Permit Number: 081462

This is to certify that OLD PORT RETAIL HOLDINGS LLC has
has permission to remove doorway area between spaces 8 & 9 MV Bldg which is on-load bearing and has support already in place
AT 436 FORE ST C-032 R007001

City of Portland, Maine - Building or Use Permit Application

Re: Opening in Bearing Wall - 51 Wharf Street, Portland, Maine
CME Project No. 08-067

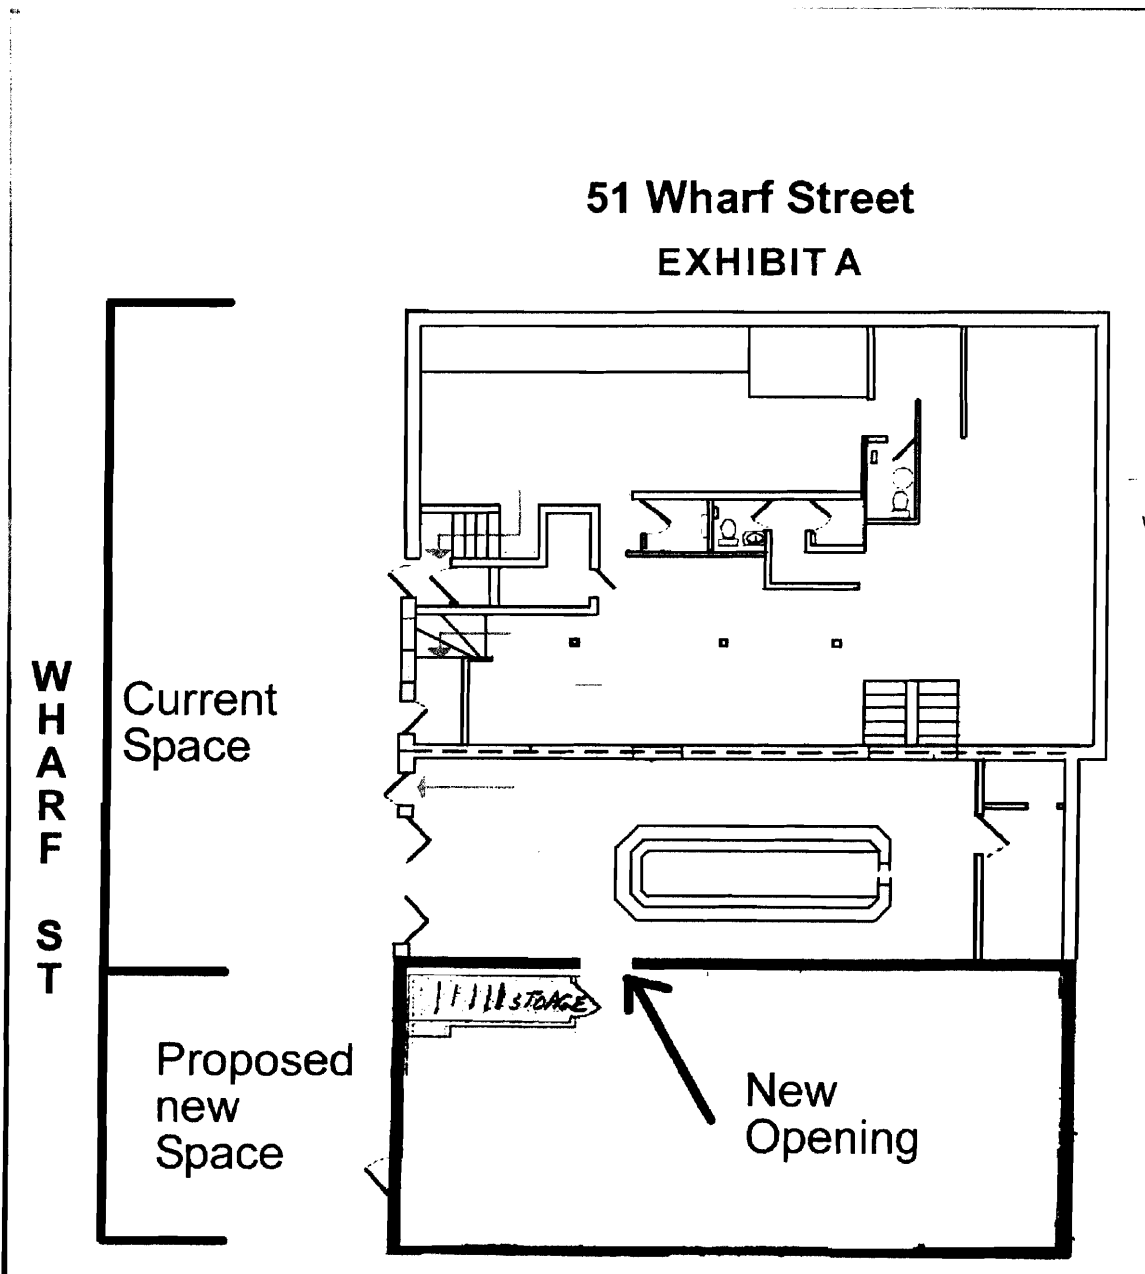
As the engineer has stated, we would like to open up the space between 47-51 Wharf Street (aka 51 Wharf Restaurant & Ultra Lounge) and 45 Wharf Street (aka Thai'd N Knots and "proposed new space" for 51 Wharf). The proposed opening has 8-inch CMU blocks and a concrete beam to support the proposed opening (please see detailed information from Criterium Mooney Engineers for more information). We would like to remove the blocks and obtain an opening available to the specified building code.

Pass thru
